TENANT IMPROVEMENT PLAN CHECK COMMENTS

PLAN CHECK NO:	10174128		
PROJECT ADDRESS:	5 E Hutton Center Dr Unit# 1050		
PLAN CHECK ENGINEER:	Ahangian, Kathy	TEL: 714	647-5812
		FAX: 714	647-5897
TYPE OF CONSTRUCTION:	I A, SPK		
OCCUPANCY CLASSIFICATION(S):	B		
PLAN CHECK DATES:	REMARKS/RECHECK ITEMS:		
APPLICATION	2/8/2012	_____	
INITIAL REVIEW	2/18/2012	_____	
EXPIRATION	8/6/2012	_____	
RECHECKS:	1. 2-28-12	PROJECT APPLICANT CONTACT PERSON:	
	2. 2-29-12	Judy or Mark Yam	
	3.	TEL:	(626)675-9882
VALUATION:	\$149,500.00	FAX:	_____
FLOOD ZONE:	X-0602320278J	EMAIL:	meiyeeyam@sbcglobal.net

Project Name
MICHAEL F MORAN
4,185 R.S.F.

MICHAEL F MORAN
5 HUTTON CENTRE DRIVE
SUITE 1050
SANTA ANA, CA 92707

FRAMELESS GLASS WALL
 SCALE: 3"=1'-0" WA03 2 2

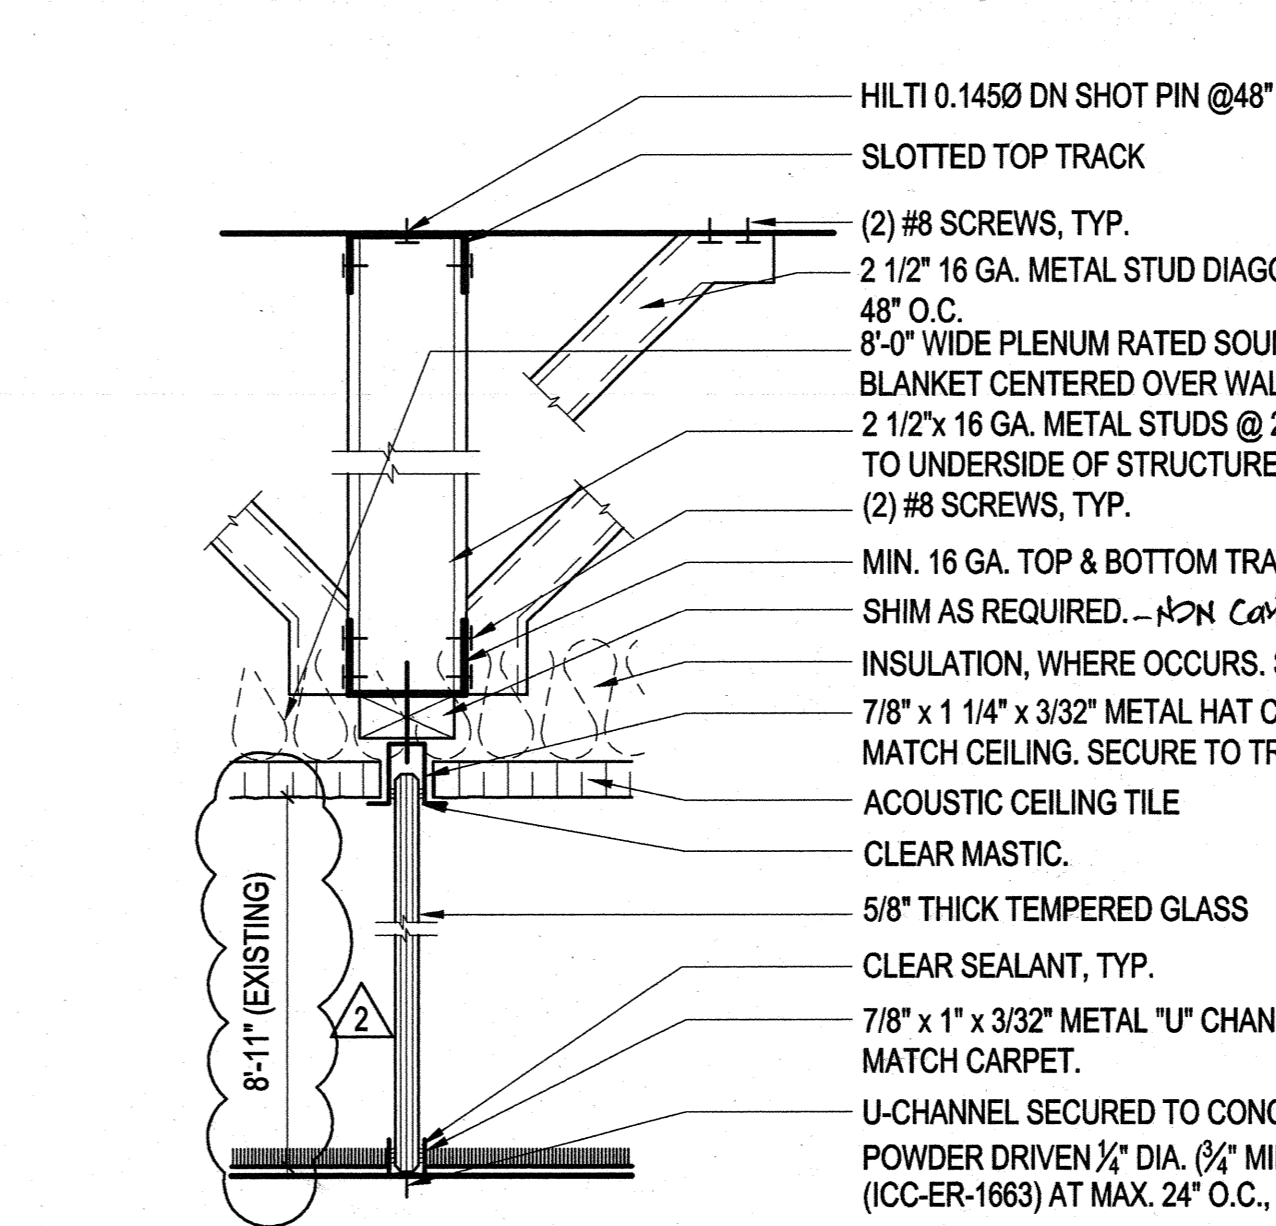
25 on detail $\frac{2}{A-12}$ Add ~~not~~ No combustibe material. see revised detail $\frac{2}{A-12.00}$

CEILING HEIGHT WALL
 SCALE: 3"=1'-0" WA01 1 1A 1

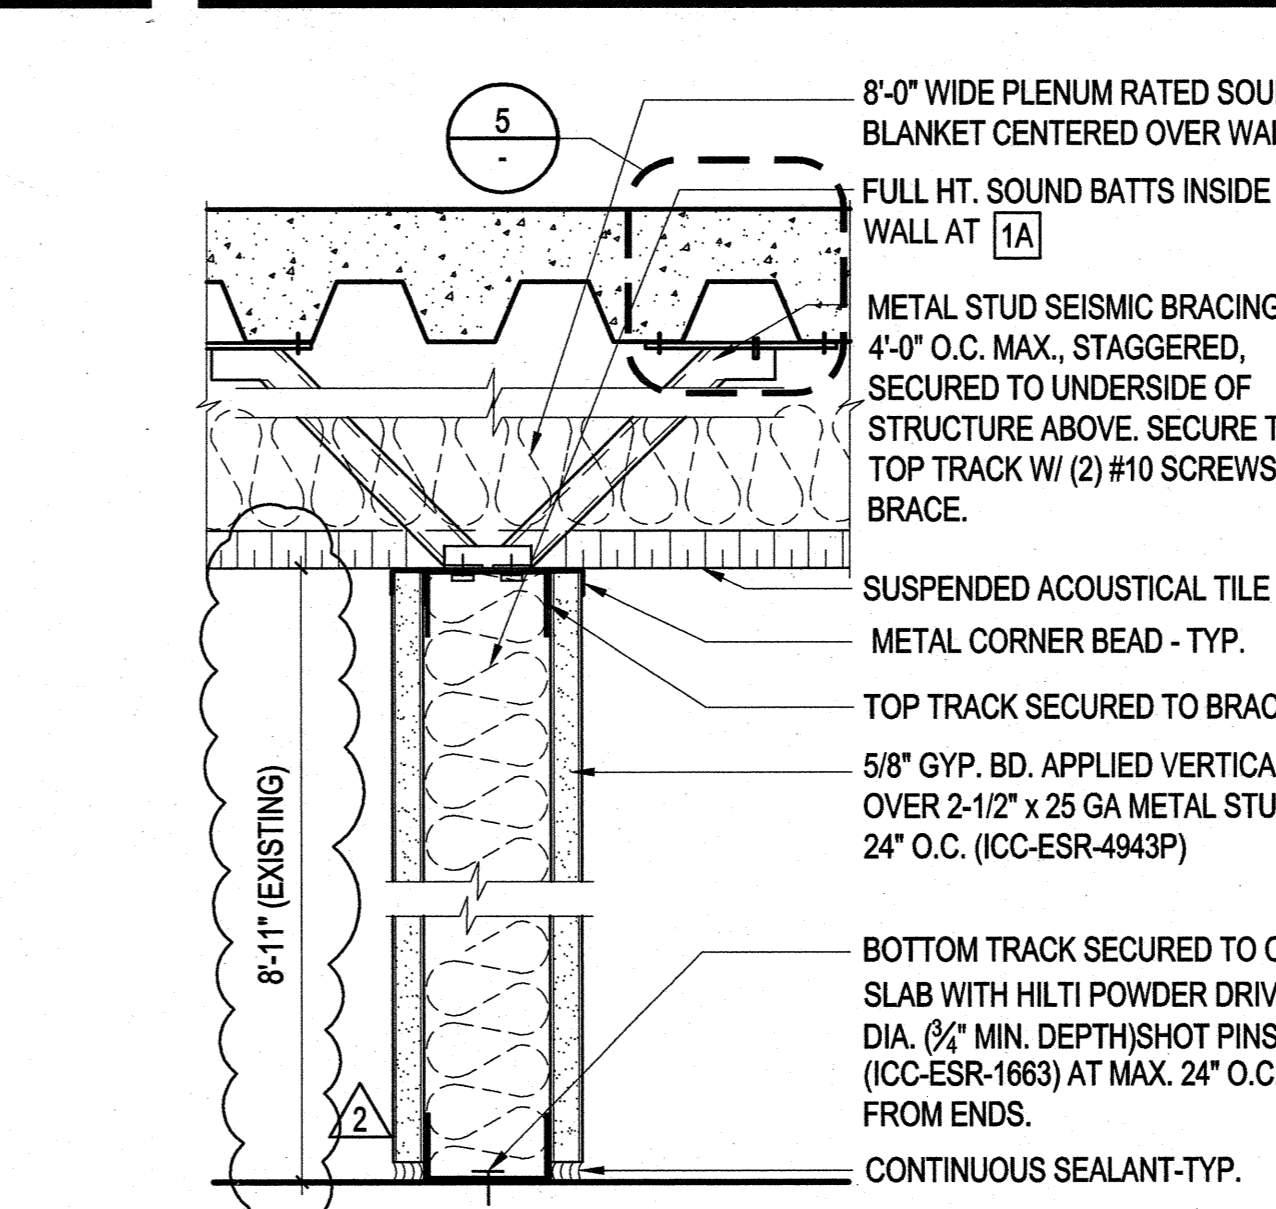
15. Show height of the partition wall on detail 1/A12. See dimension added A12.00
